**The W Nursing School
Neshoba General
Philadelphia, MS**

Addendum No. 2

June 10, 2026

This addendum forms a part of the contract documents and modifies the original plans and specifications dated June 4, 2026.

sheet no.
A-502
of

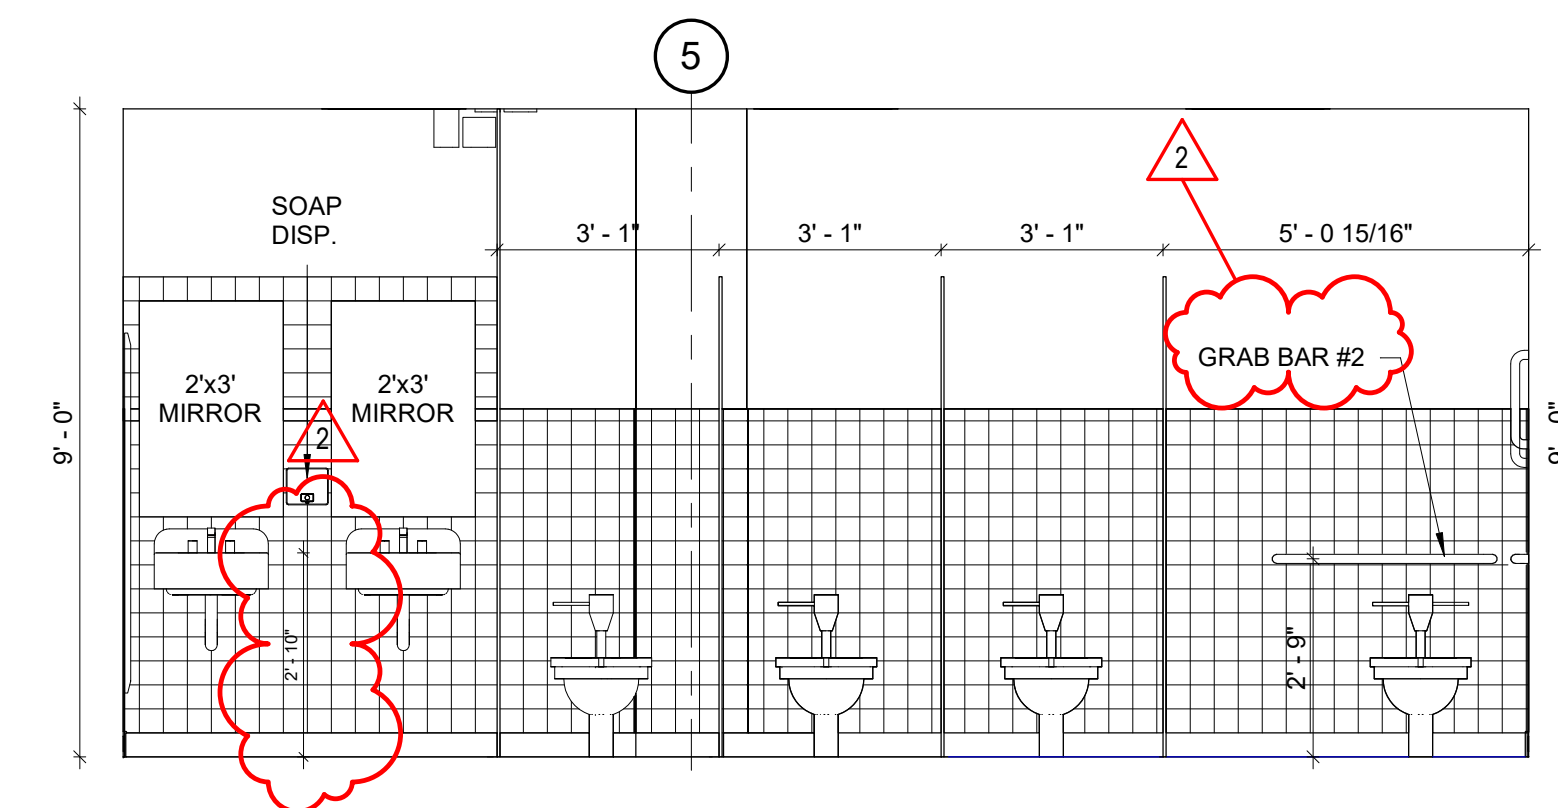
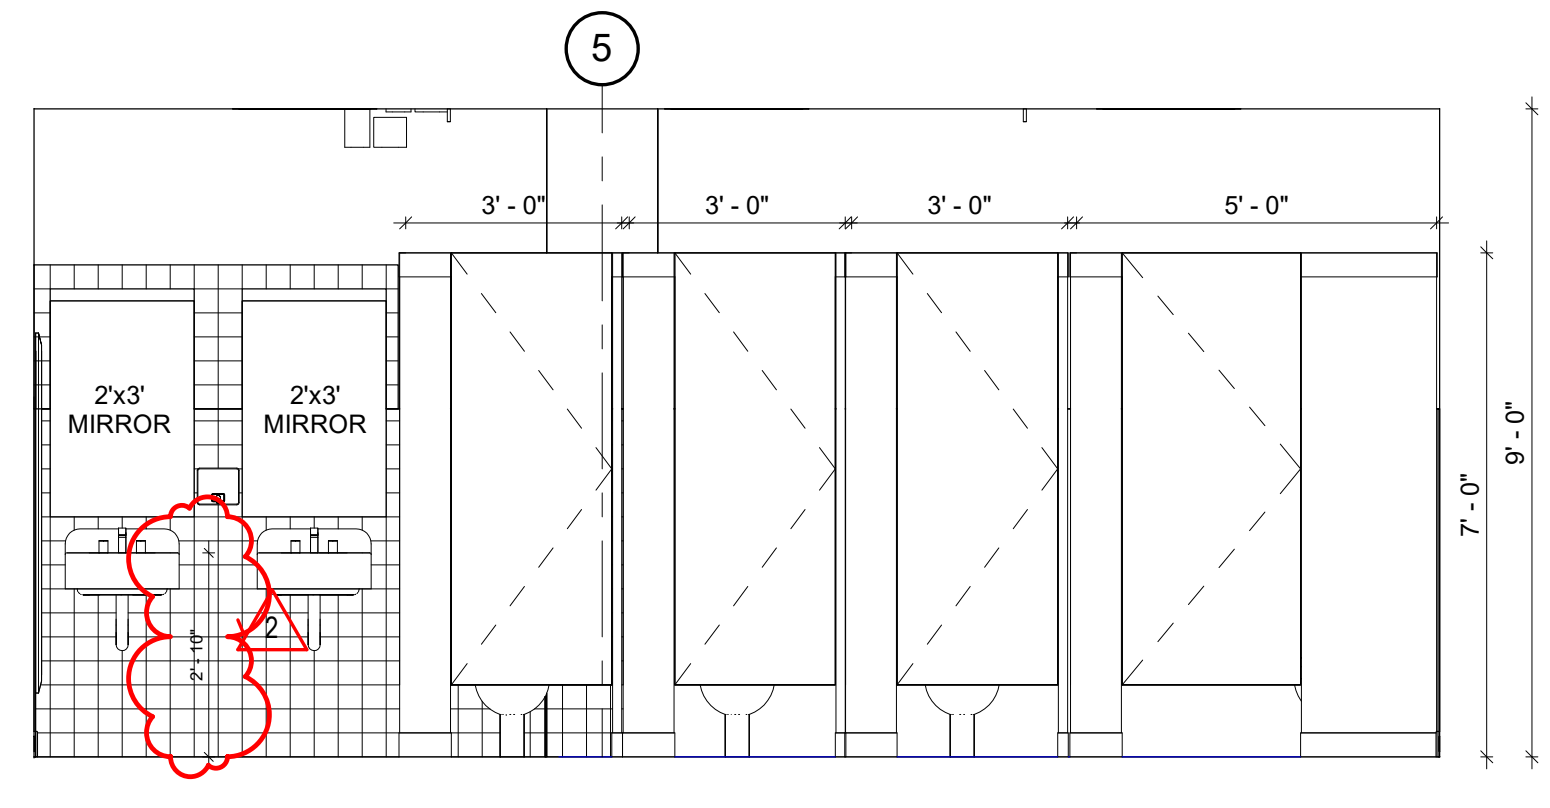
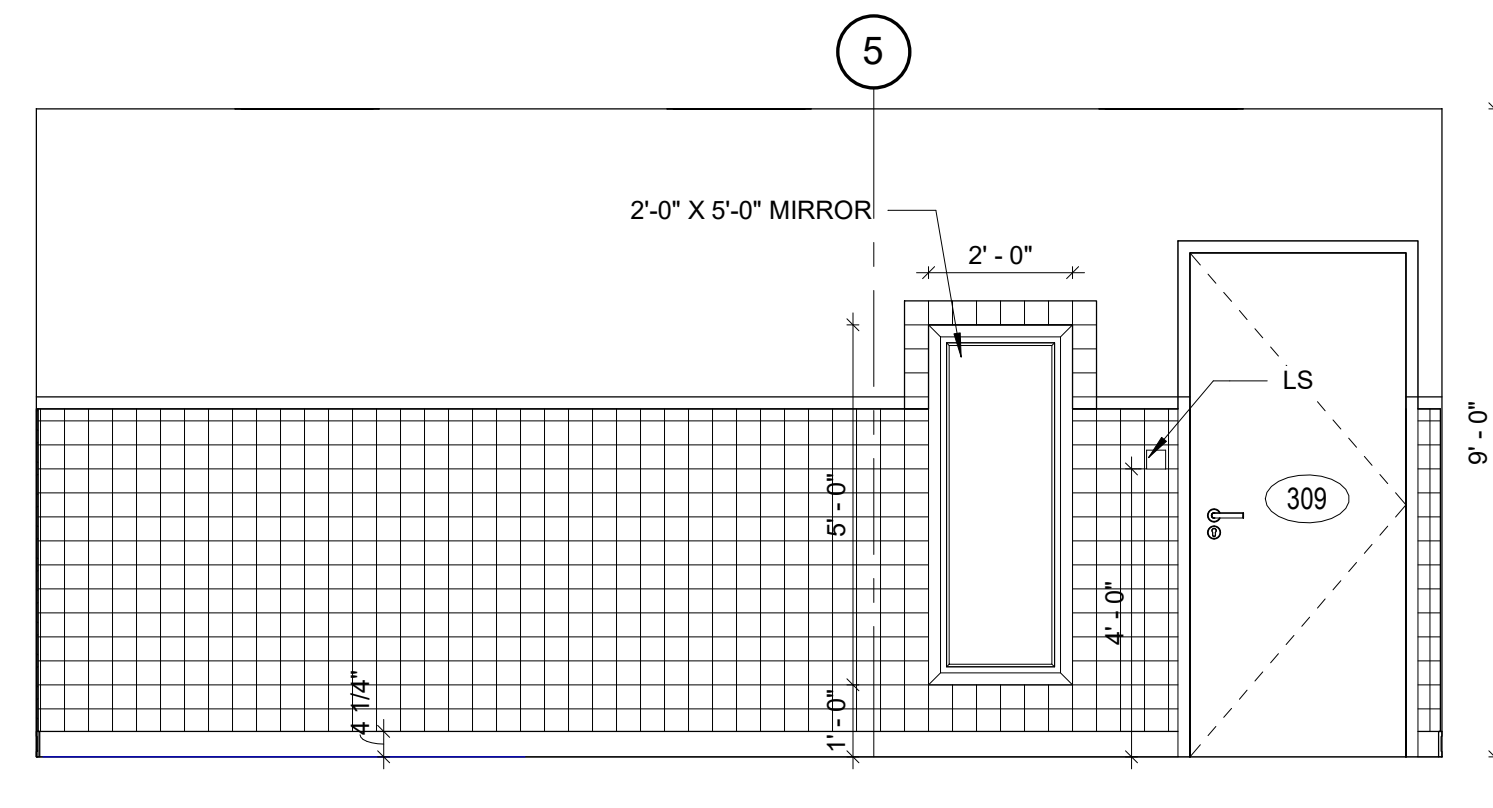
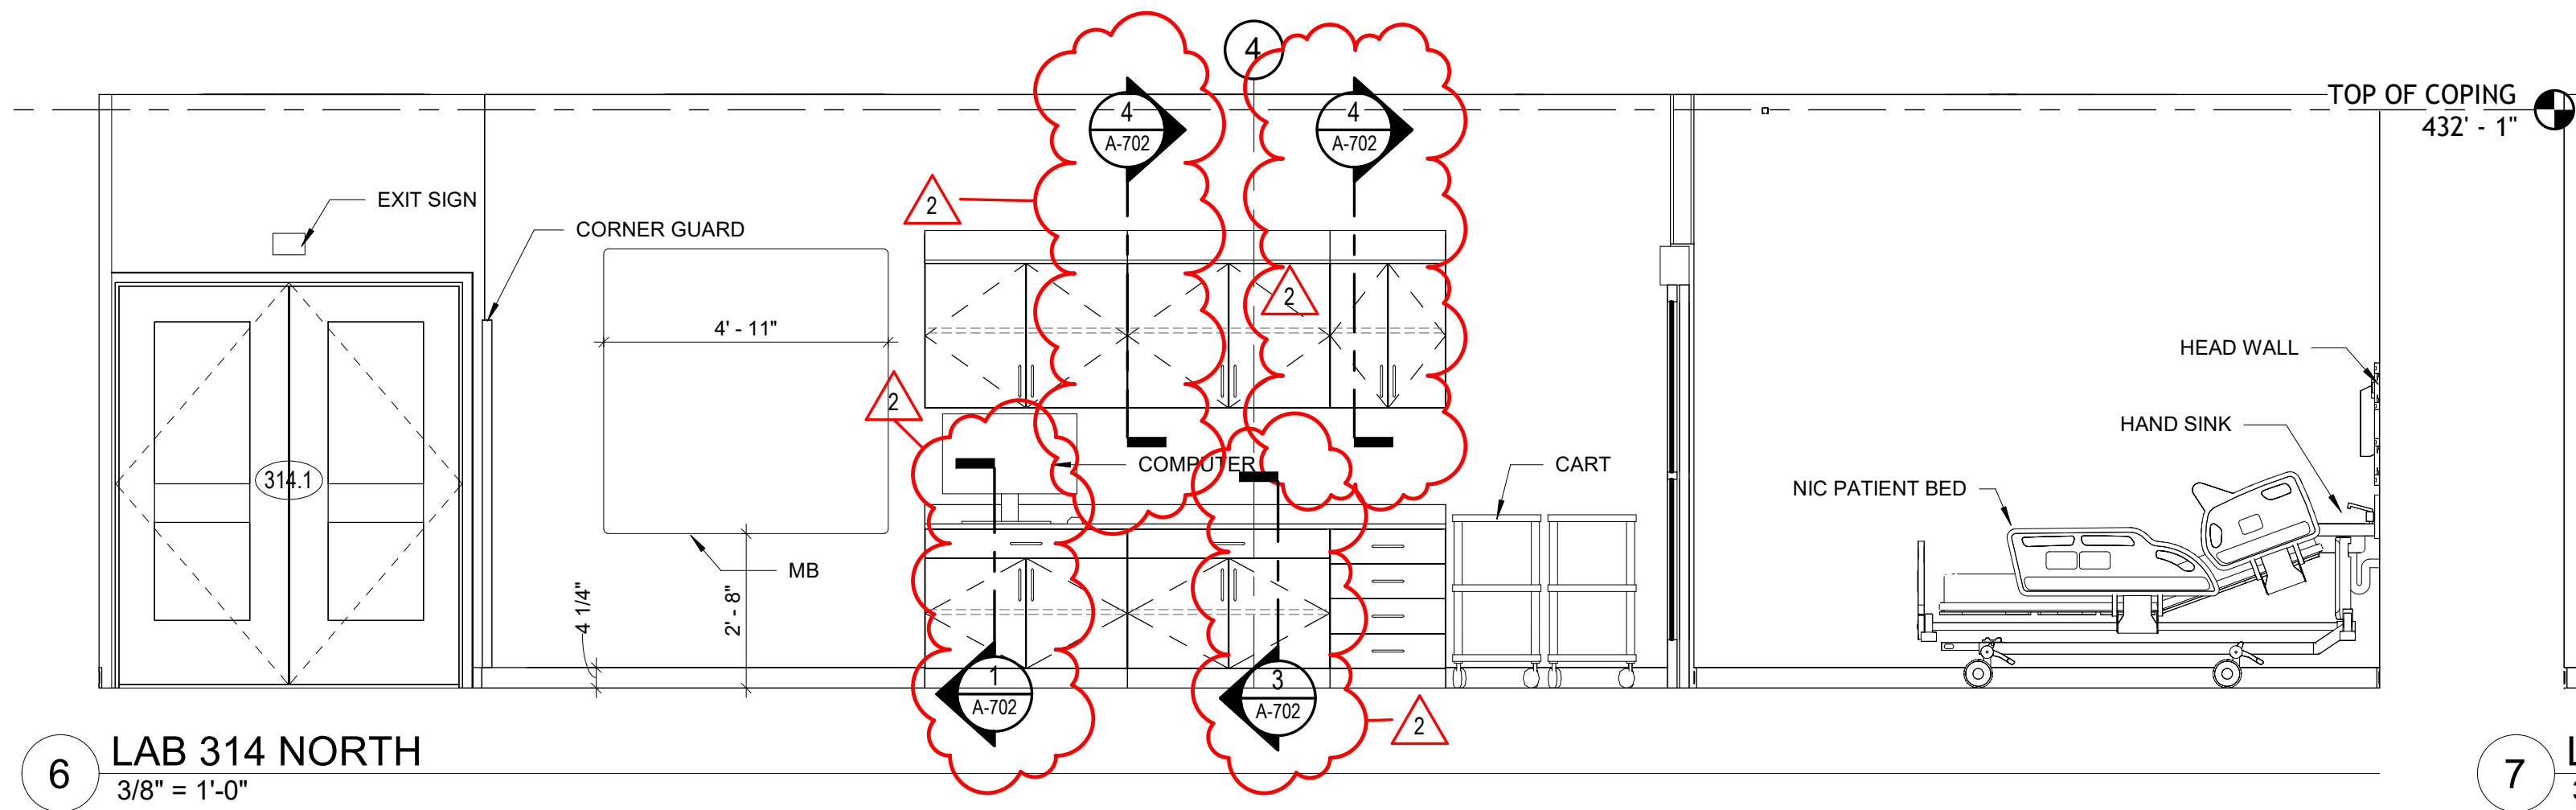
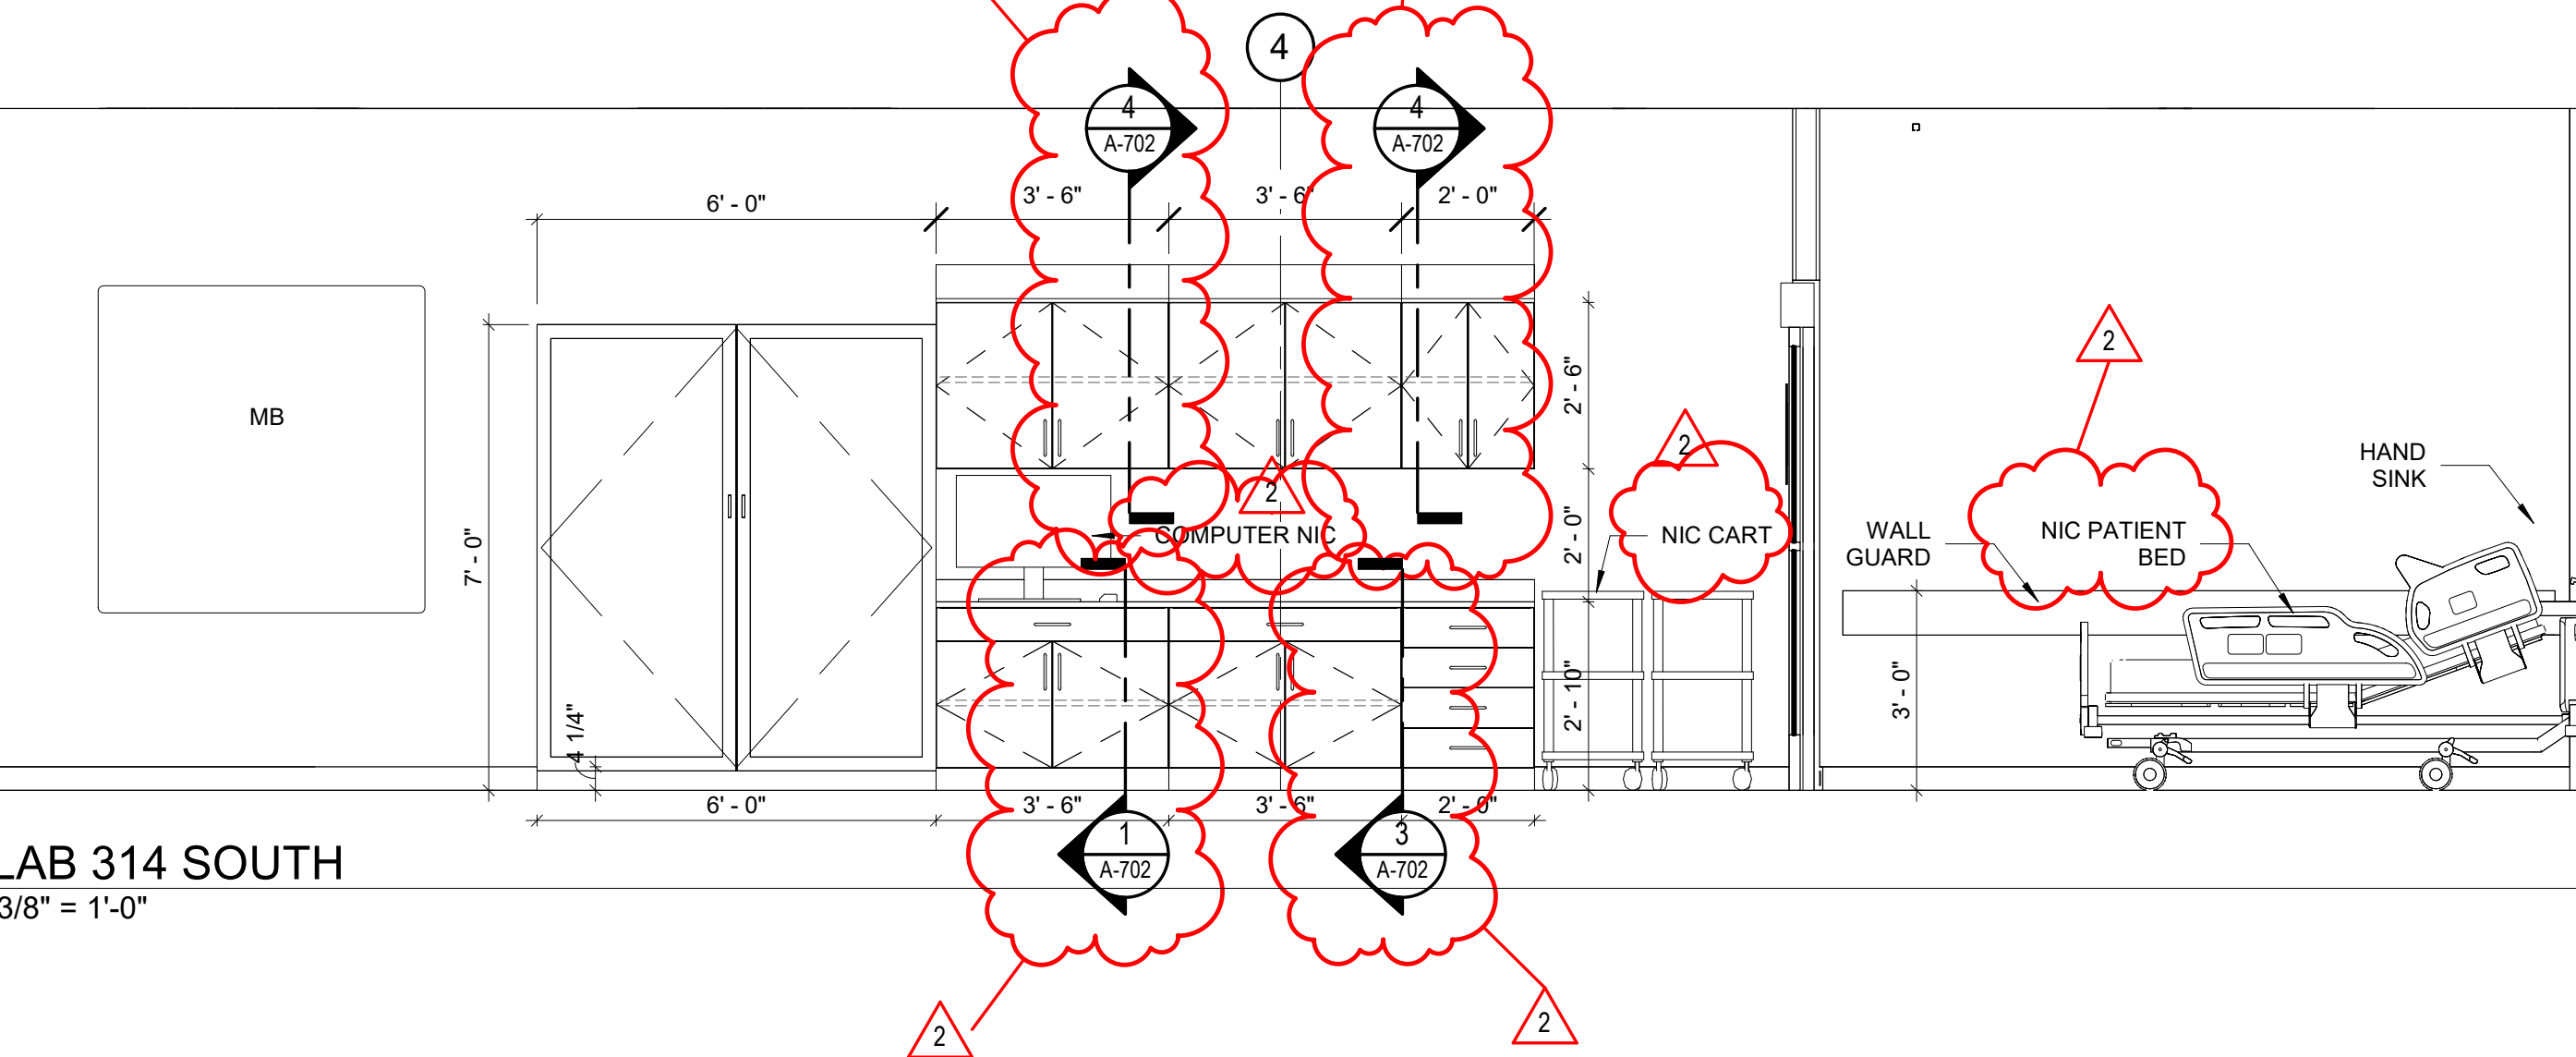
Item 2.10: Sheet A-502

Note: See clouded millwork detail references.
